Well Name	Well Number	US Well Number	Lease Number	Case Number	Operator
TAILS CC 10_3	35H	3001548965	NMNM081616	NMNM081616	OXY USA
TAILS CC 10_3	31H	3001548881	NMNM81616	NMNM81616	OXY USA
TAILS CC 10_3	32H	3001548880	NMNM81616	NMNM81616	OXY USA
TAILS CC 10_3	36H	3001548964	NMNM081616	NMNM081616	OXY USA
TAILS CC 10_3	312H	3001548930	NMNM81616	NMNM81616	OXY USA
TAILS CC 10_3	33H	3001548879	NMNM81616	NMNM81616	OXY USA
TAILS CC 10_3	38H	3001548877	NMNM81616	NMNM81616	OXY USA
TAILS CC 10_3	34H	3001548959	NMNM081616	NMNM081616	OXY USA

Notice of Intent

Type of Action: APD Change

Procedure Description: OXY USA Inc. respectfully requests approval to amend the subject well AAPD wellhead design. See the attached diagram of the planning wellhead system for the Tails wells. The drilling rigs are currently moving onto the well pads to being drilling. OXY will use Cameron ADAPT wellhead system that uses an OEC top flange connection. This connection has been fully vetted and verified by API to Spec 6A and carries an API monogram. See the attached wellhead slide.

CAMERON ADAPT WELLHEAD - NM

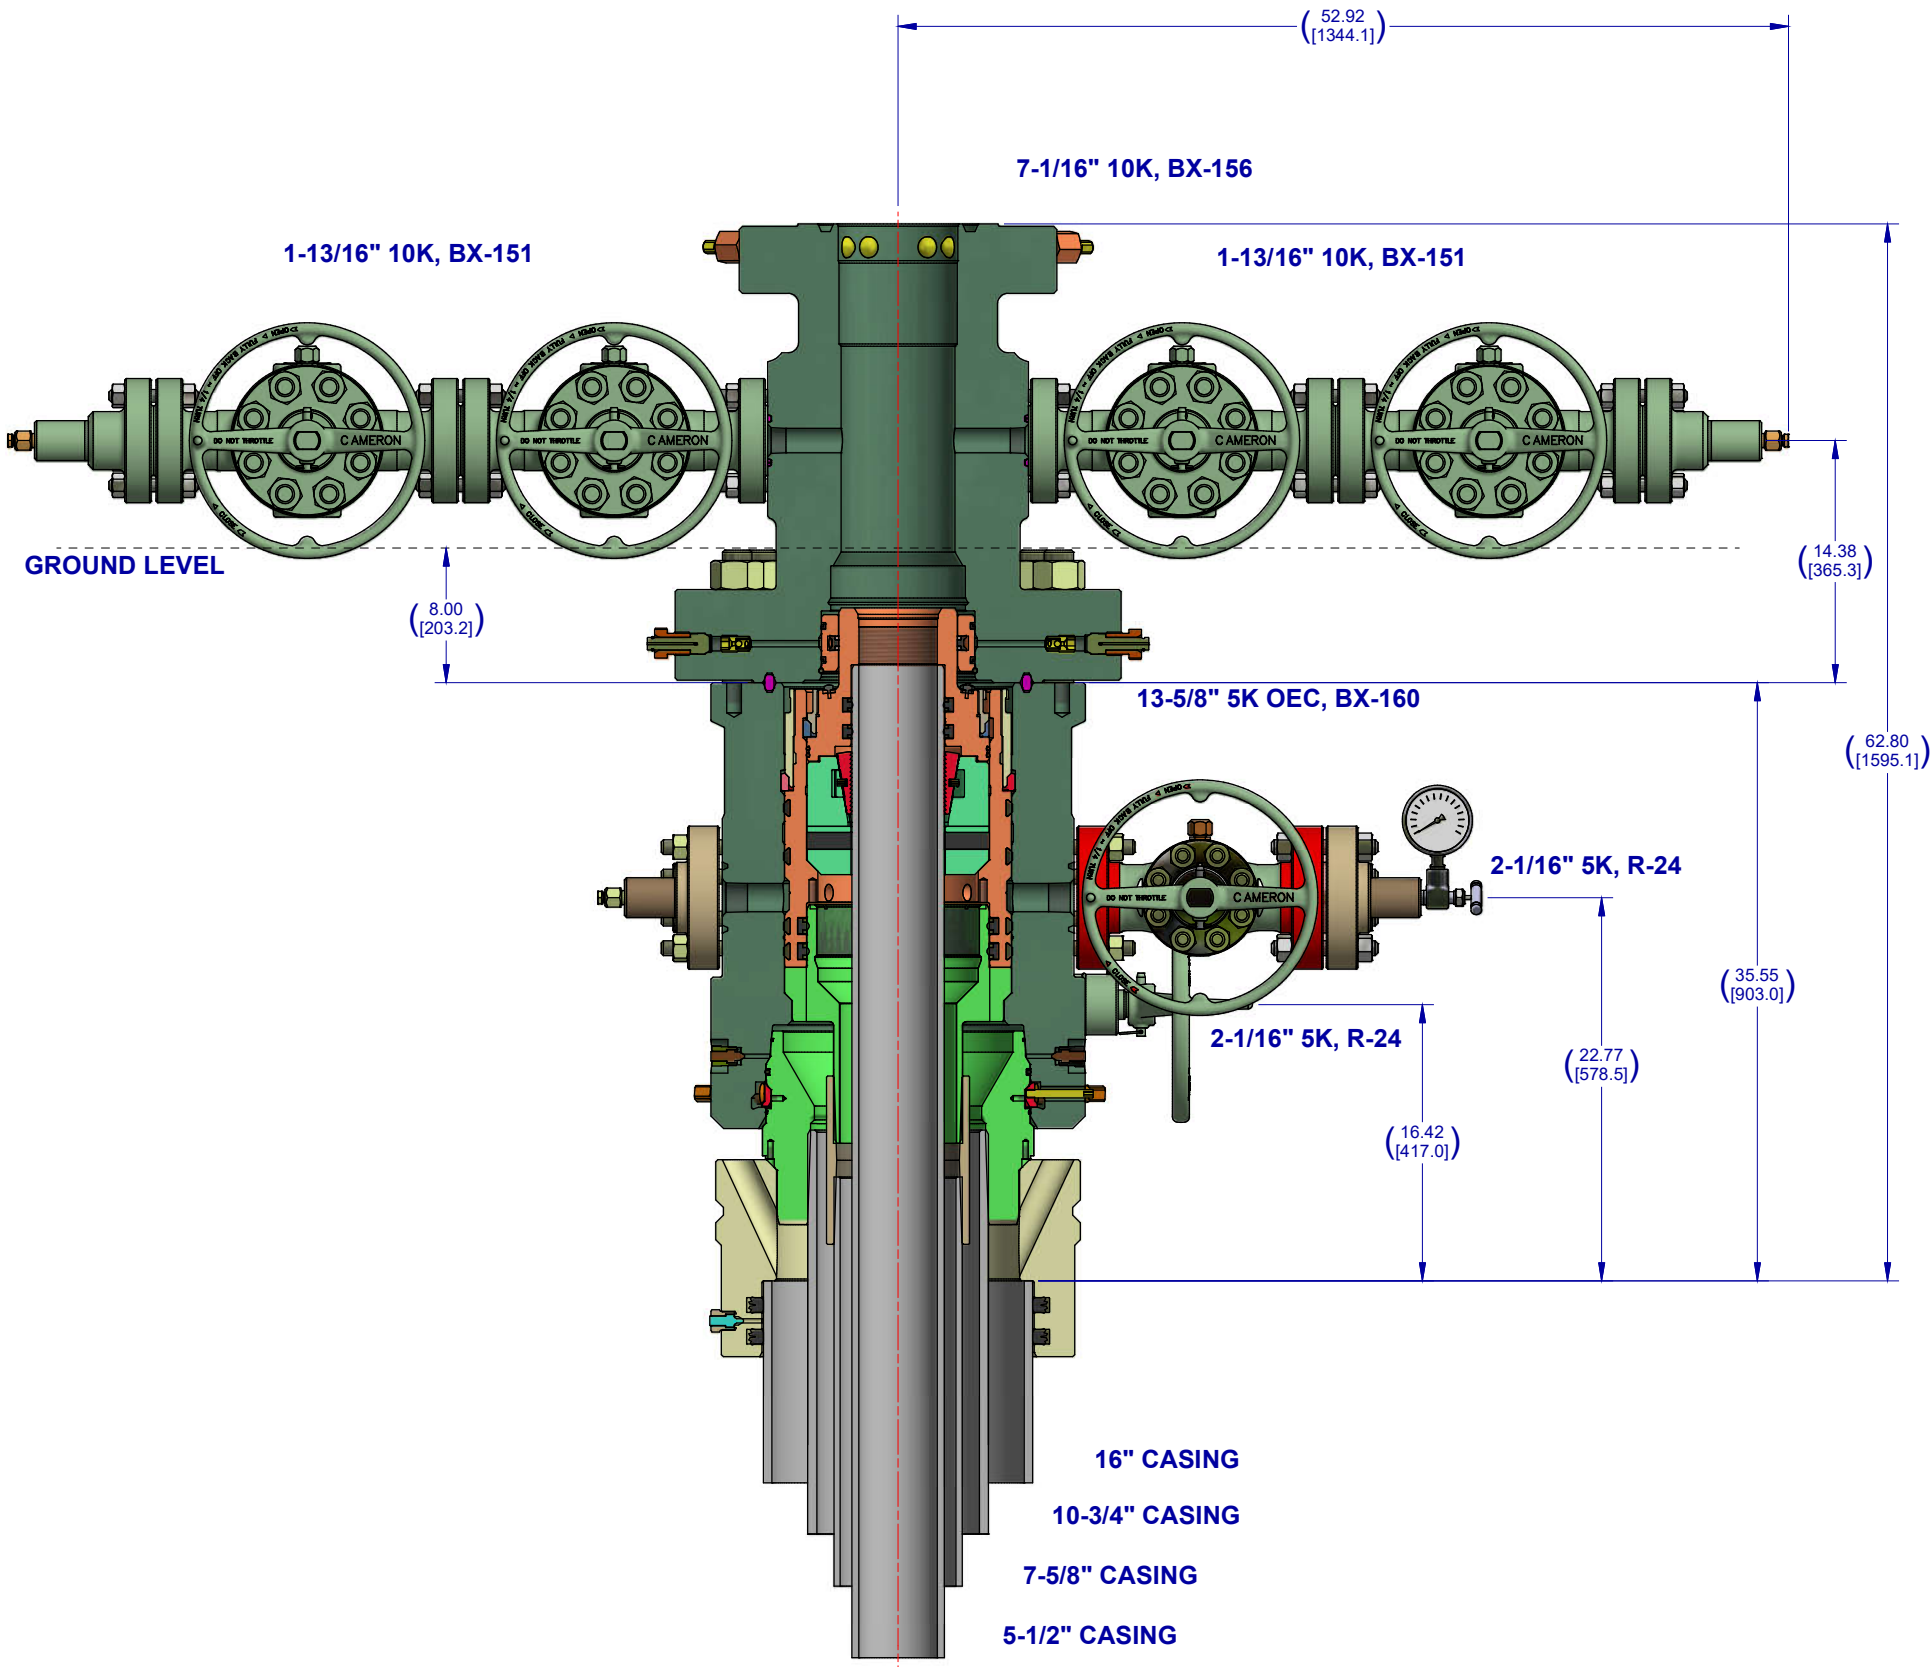
- All Wellhead Components have API monogram
 - Casing Bodies, Hangers, Tubing Spools, Valves, Slips, Ring Gaskets
 - Packoffs are not monogrammed per API
- Top connection of ADAPT casing head is not an API flange (classified as other end connector aka “OEC”),
 - Uses standard API ring gasket and has been certified and vetted by API
- R-type ring gaskets on casing head outlet valves
 - You could run RX if you wanted to
- BX-type ring gaskets for tubing spool + outlet valves
